Interactive comment on “Modelling the water balance of Lake Victoria (East Africa) – Part 1: Observational analysis” by Inne Vanderkelen et al.

Anonymous Referee #1

Fig. 1.

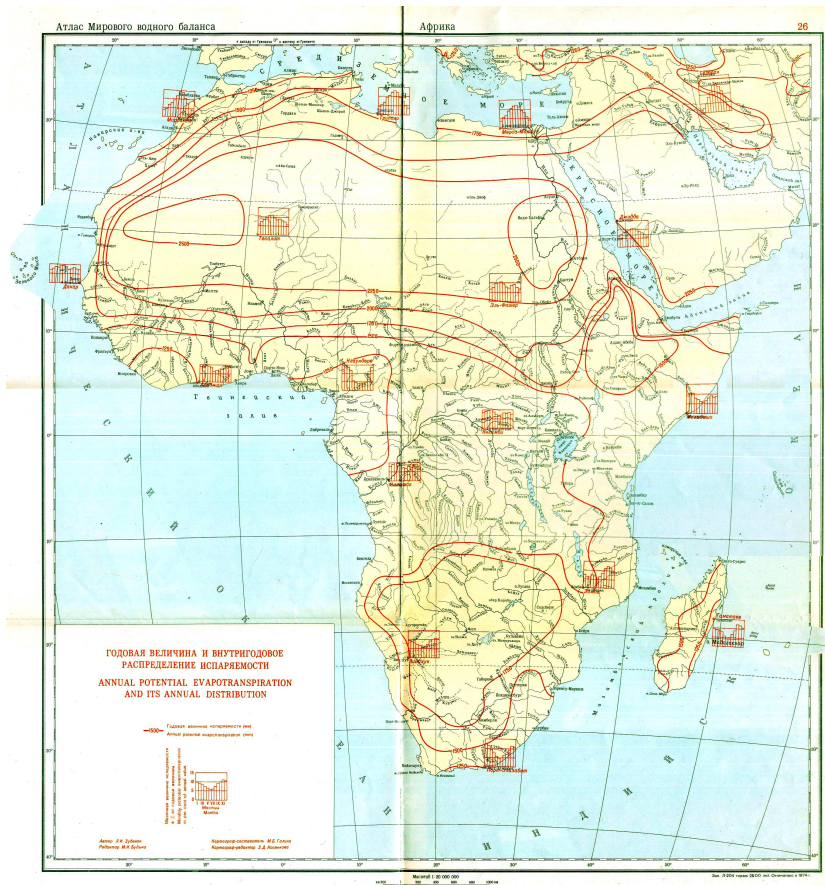
Earth& (1974) the evaporation from Lake Victoria is estimated as 1500 mm (fig.1). It confirms that the estimation of evaporation made by authors is right. It is not clear why the CN model shows that the most runoff is generated in the south west of the Lake Victoria Basin. According to Atlas "World water balance and water resources of the Earth& (1974) the most runoff is generated in the north west part in the basin (because of the relief peculiarities (fig.2). Technical corrections and questions What is the reason of absence of HYDROMET water level data after 1996? It is useful to mark points of water level observations and rain gauge stations on the fig.1. On the fig. 5 it is useful to give all water balance components in the same unit of measure (mm or m3).
